# ADDENDUM NO. 3

**August 19, 2022**

## **Additions and Renovations Hawthorne Elementary School**

ADDENDUM NO: 3

DRAWING NUMBER  
**L050**

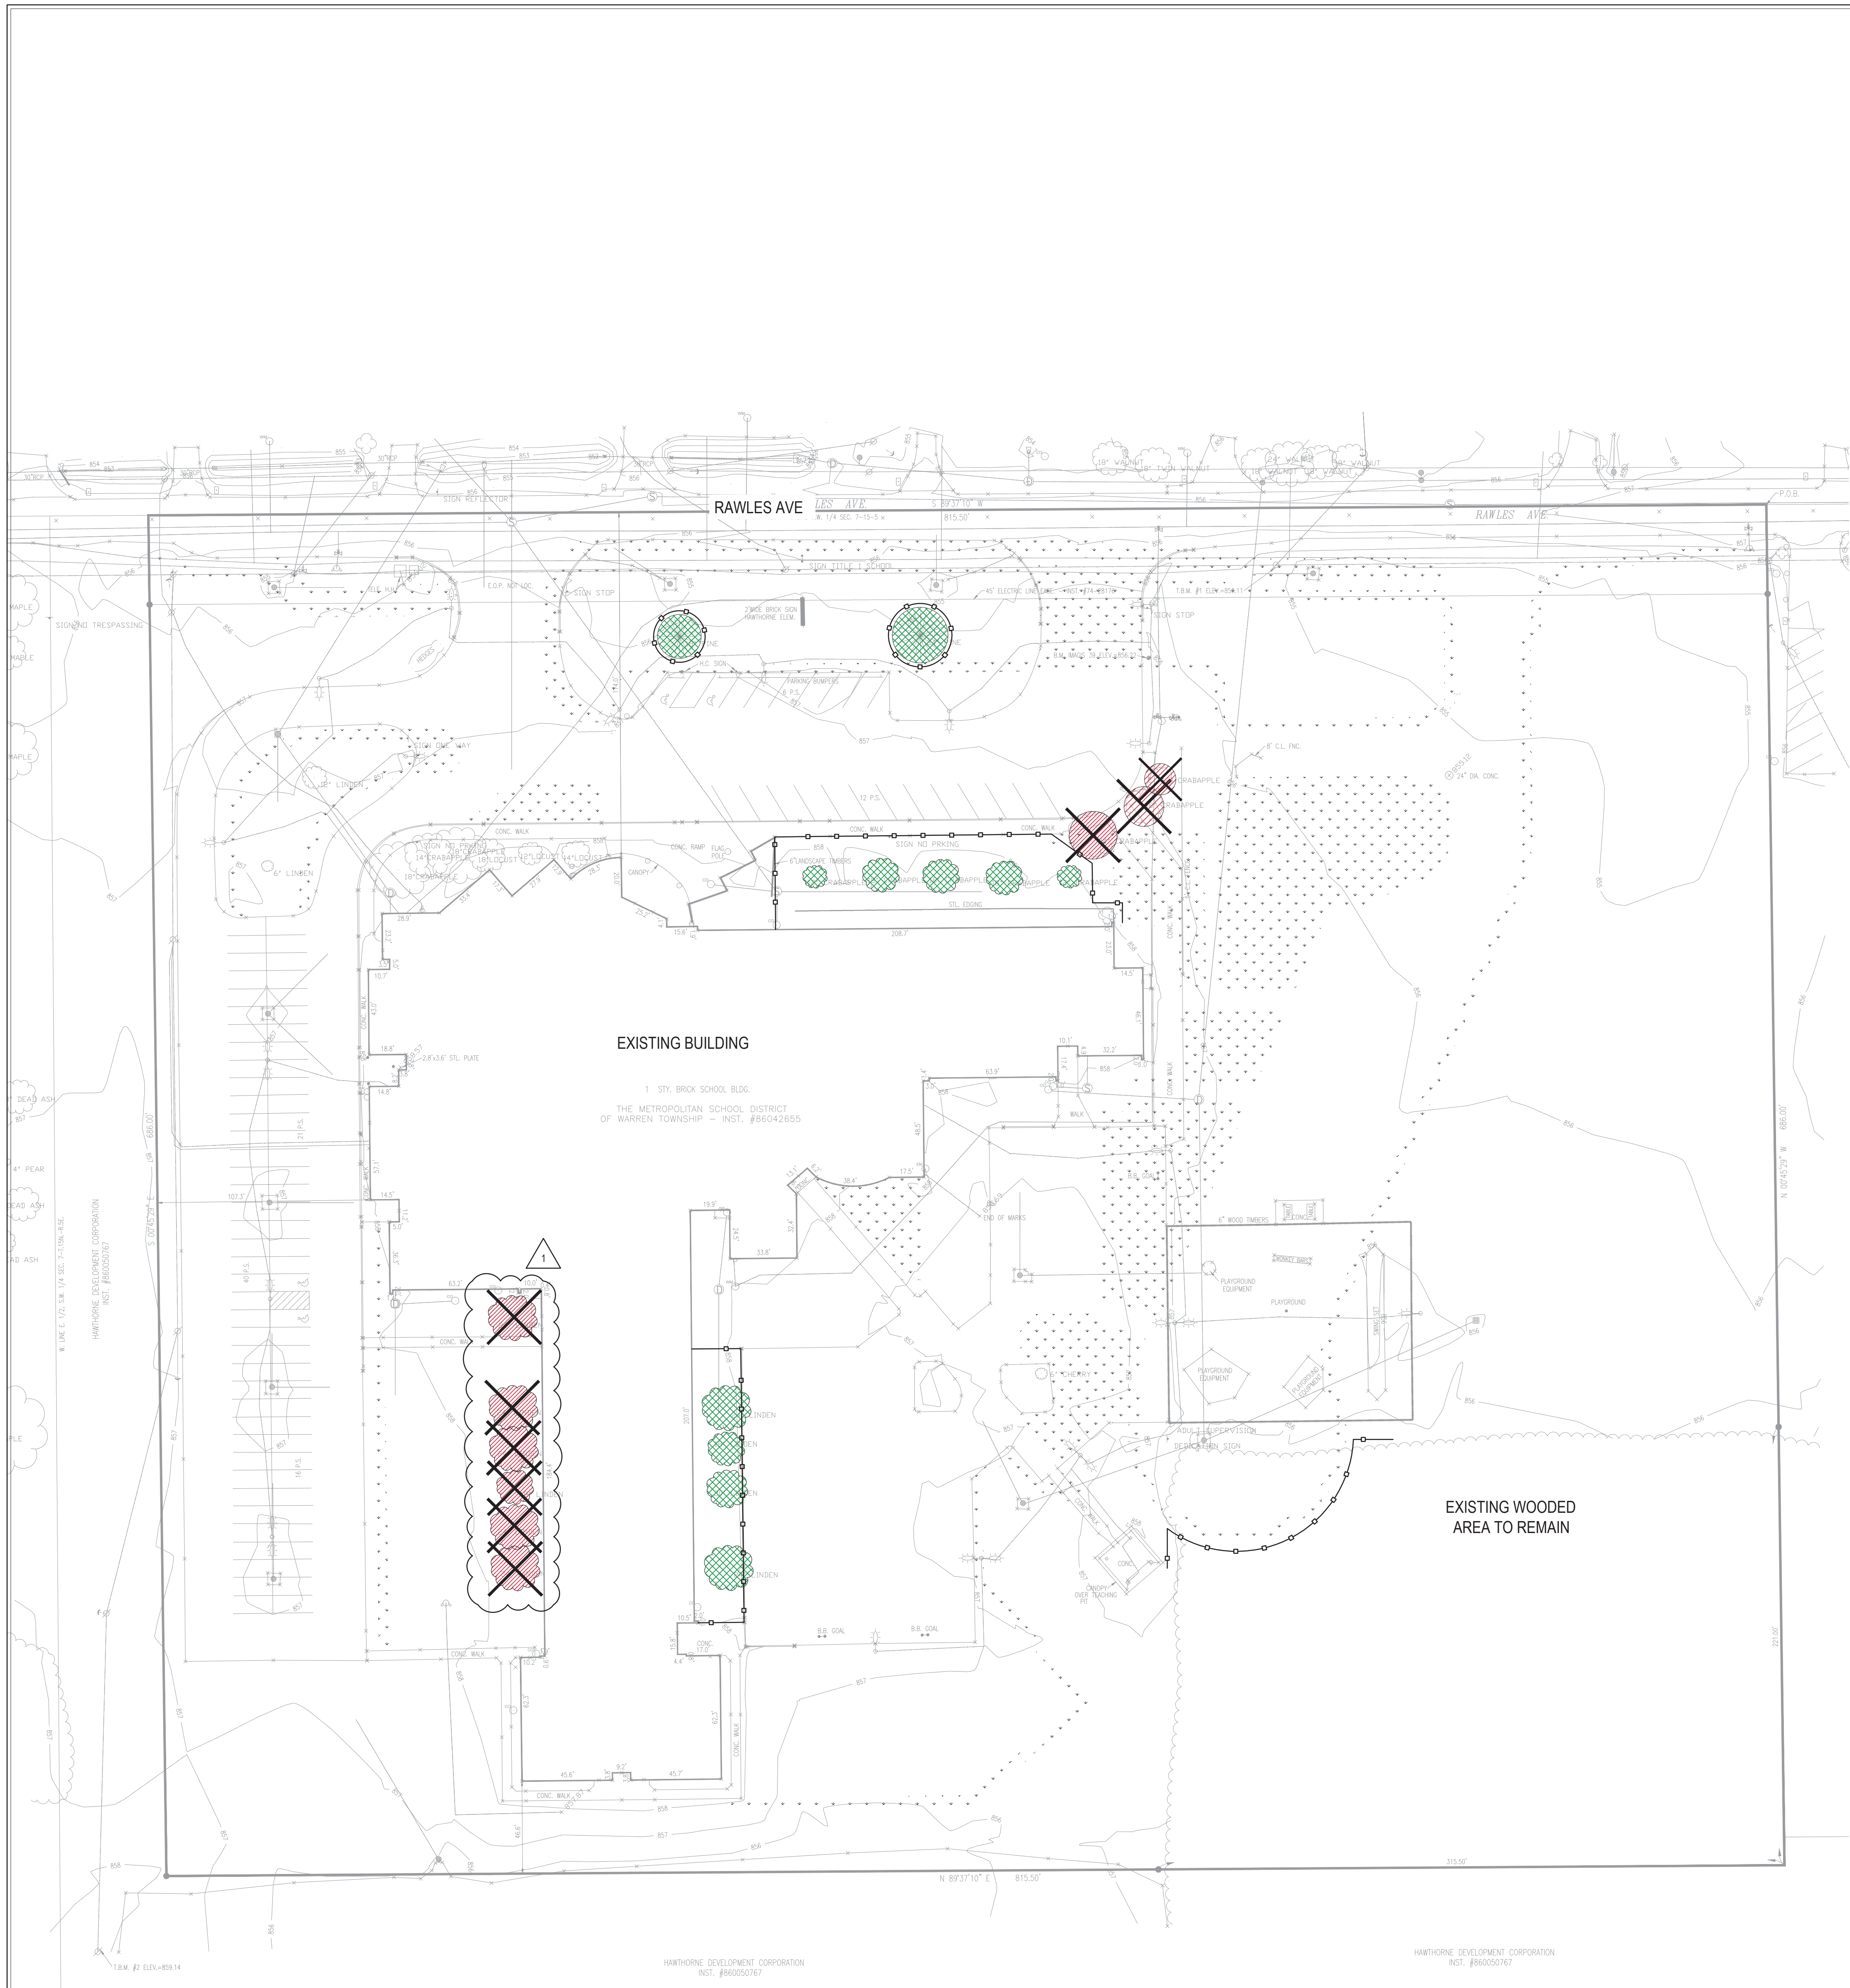
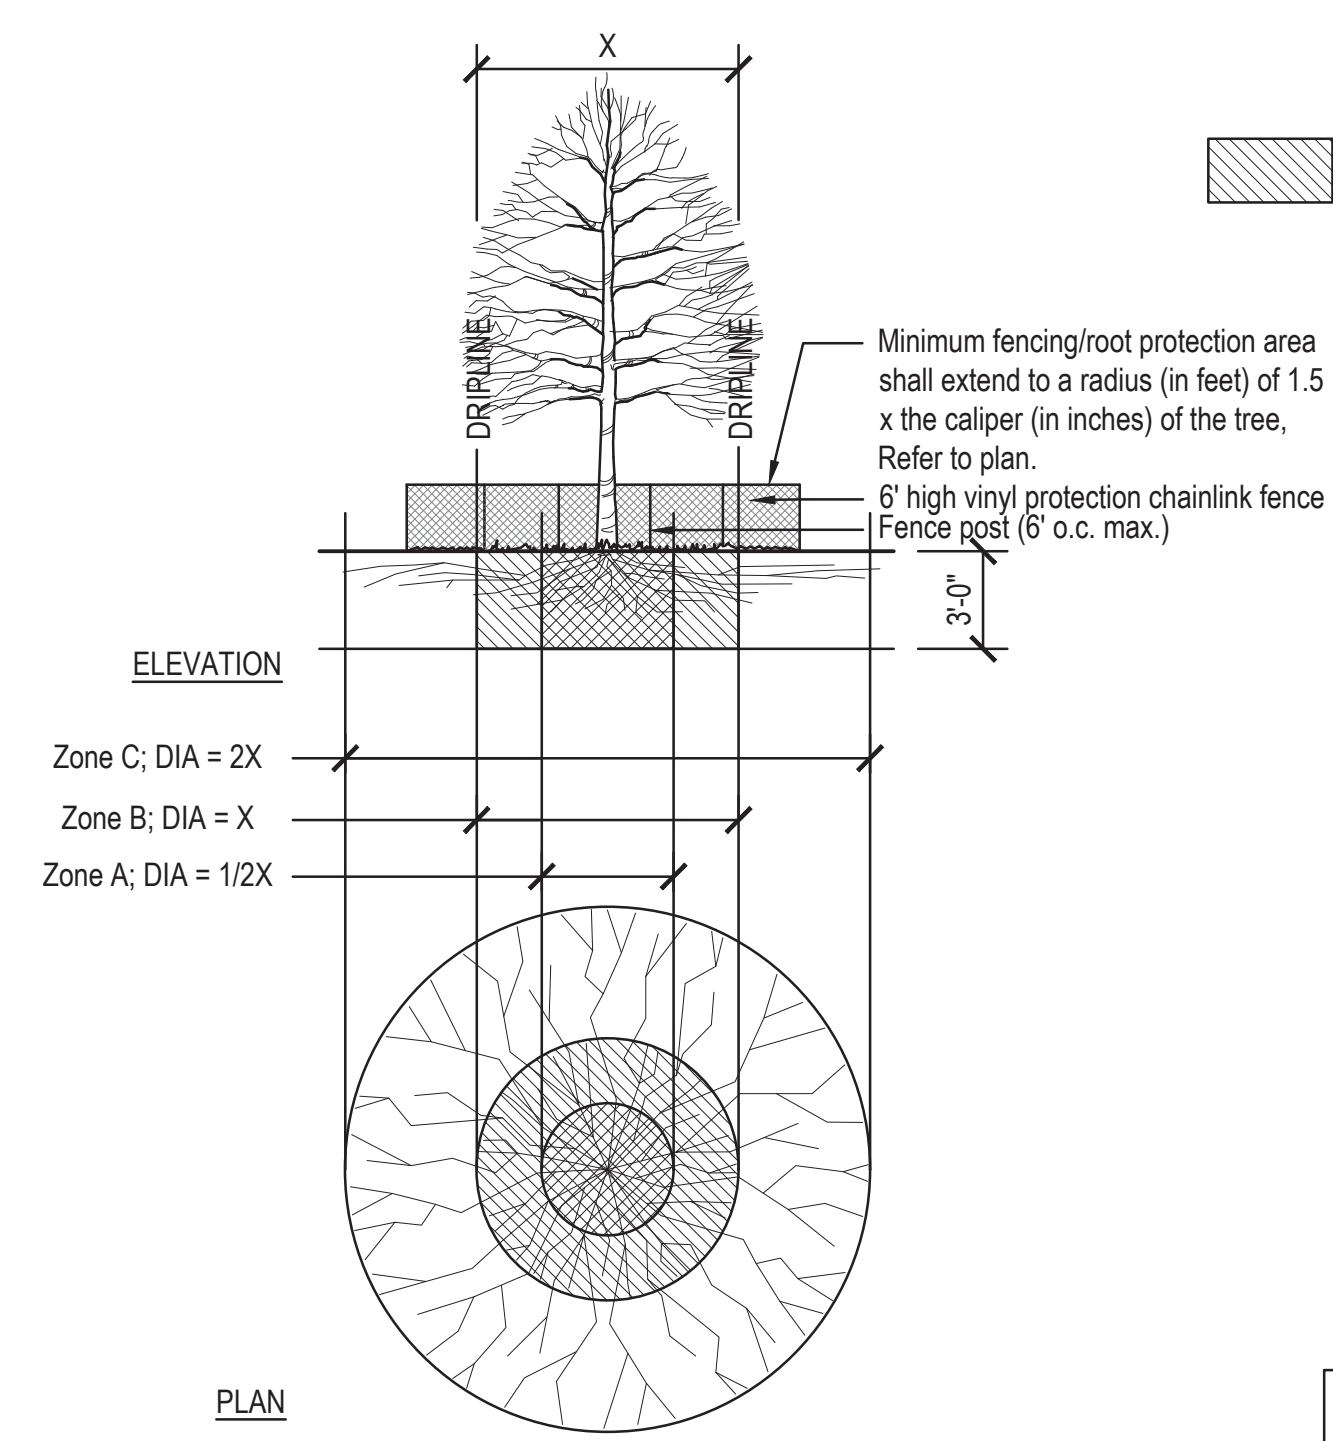
##### 3.1 SHEET L050 TREE PROTECTION AND DEMOLITION PLAN

A. Additional Tree Demolition has been added.

**DRAWING NUMBER**  
L103

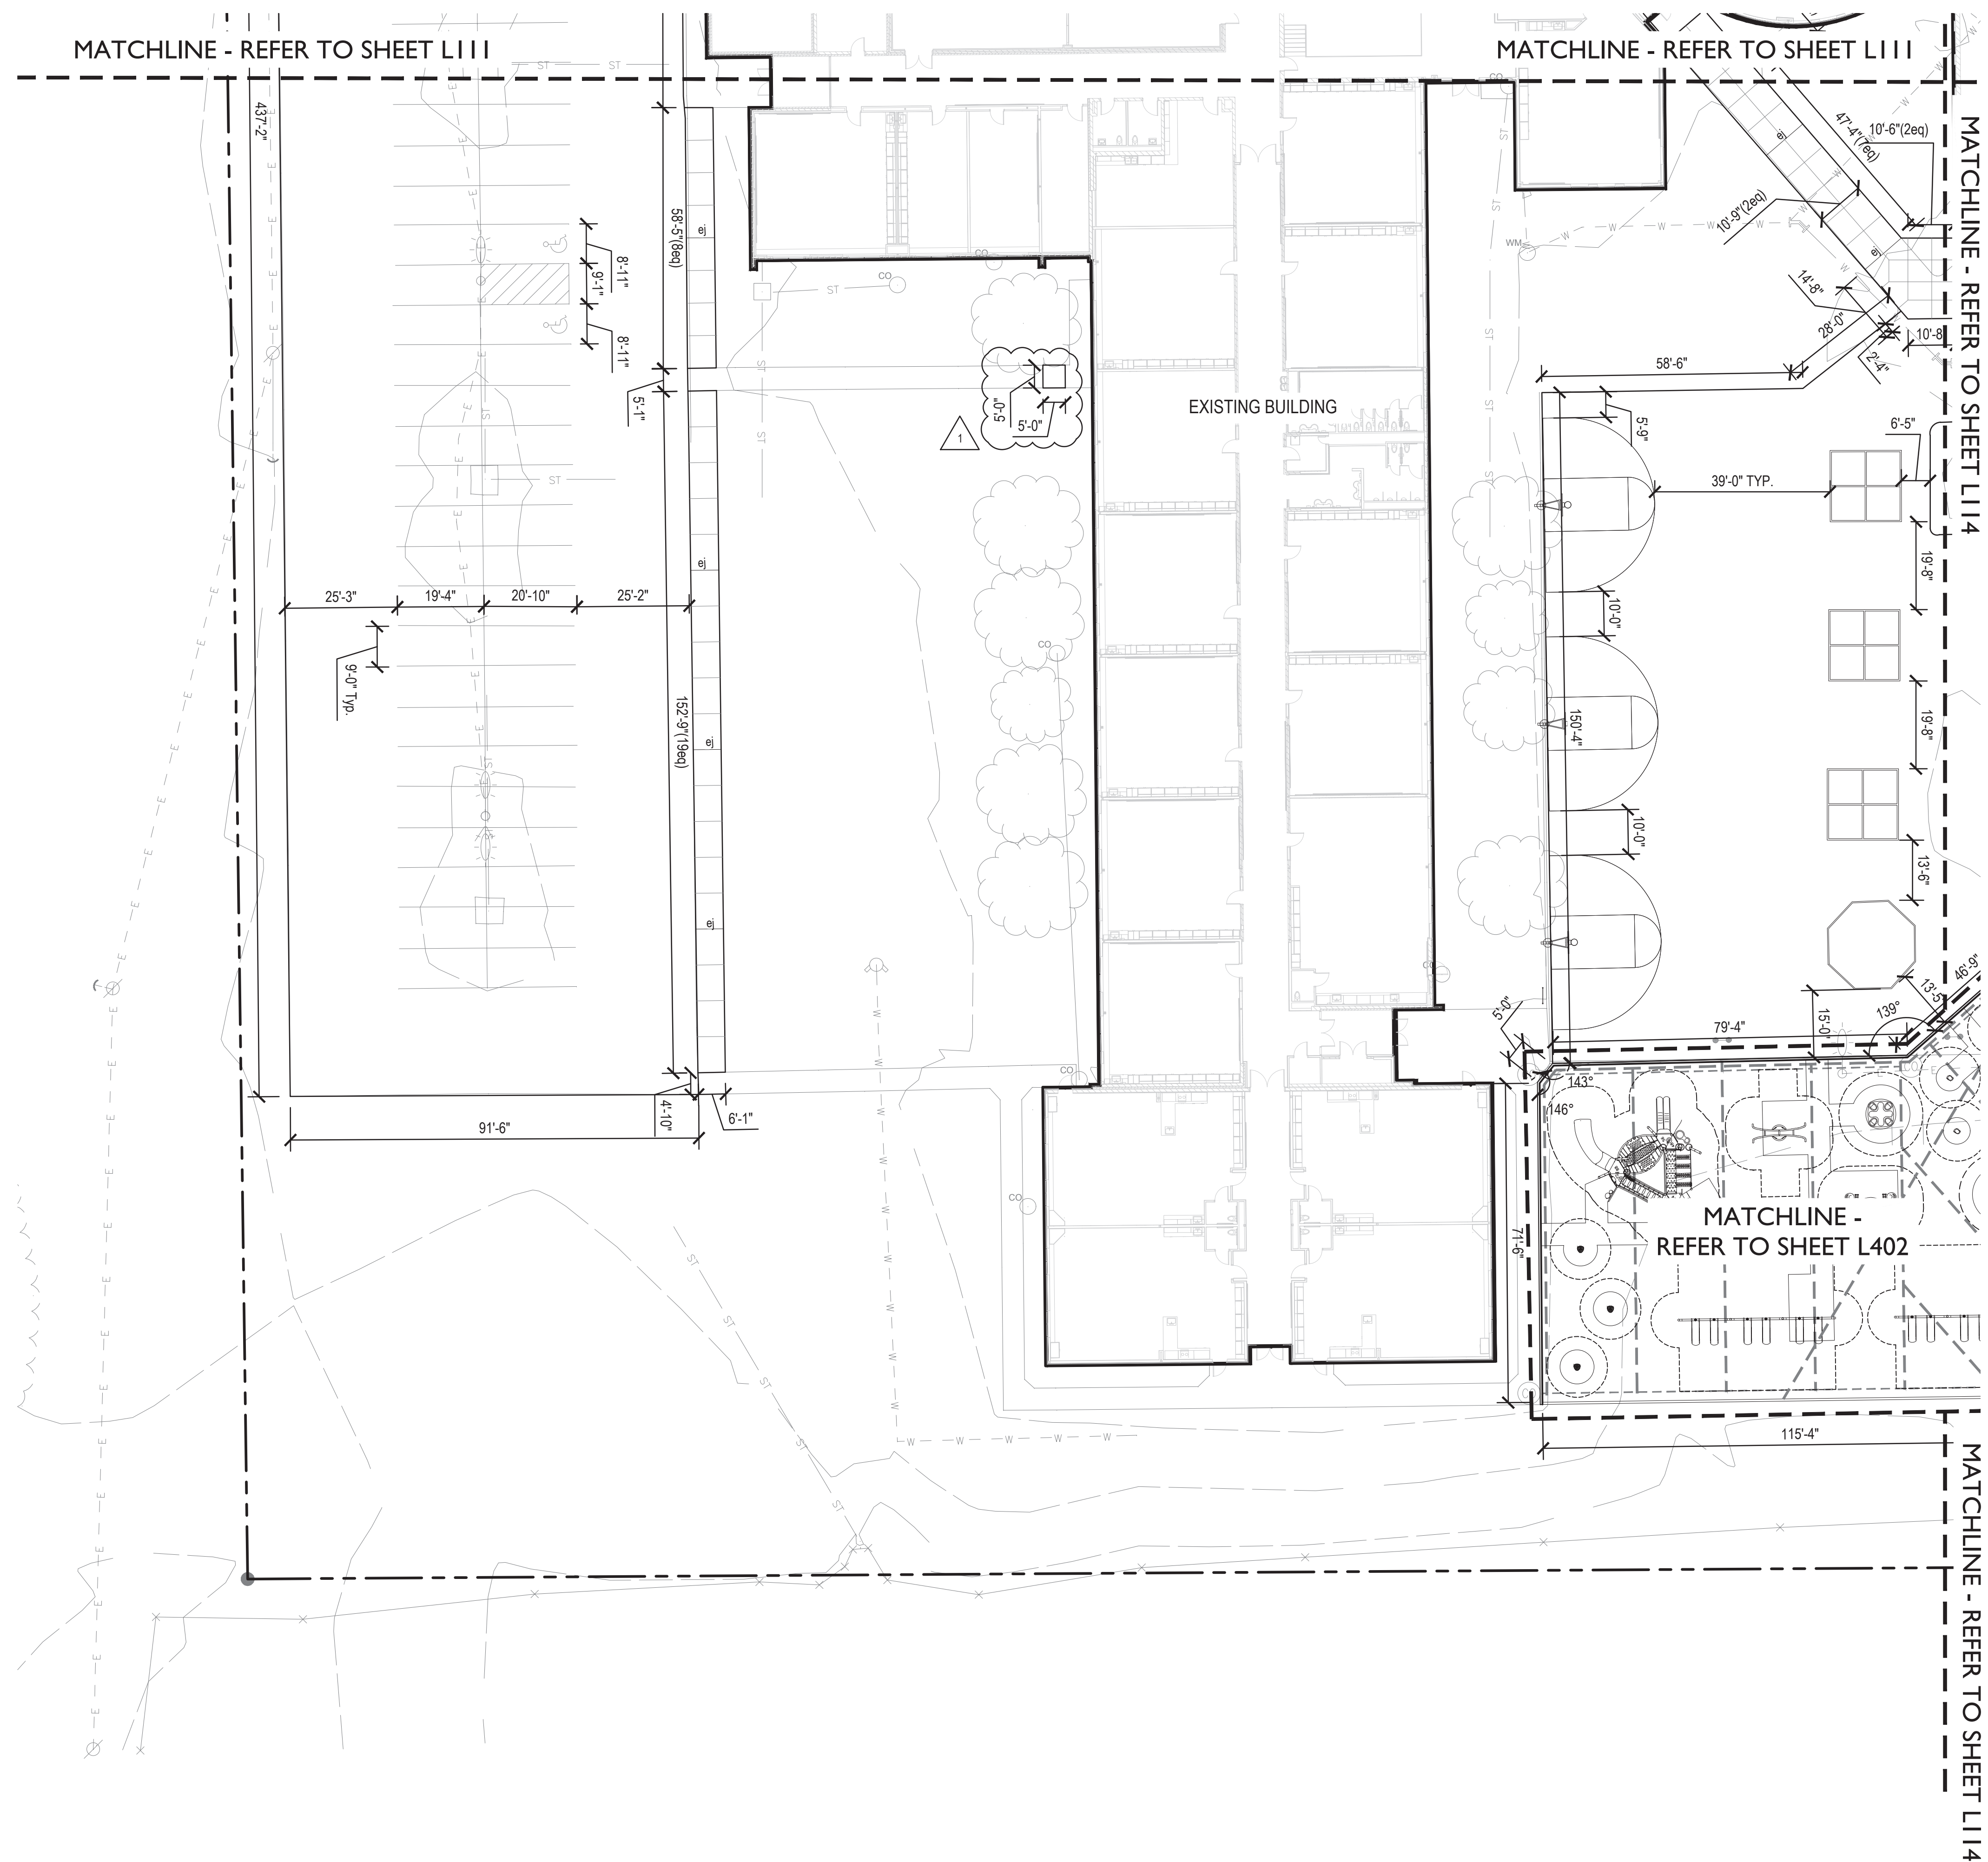
##### 3.2 SHEET L103 SITE MATERIALS PLAN

A. Additional concrete sidewalk replacement has been added.
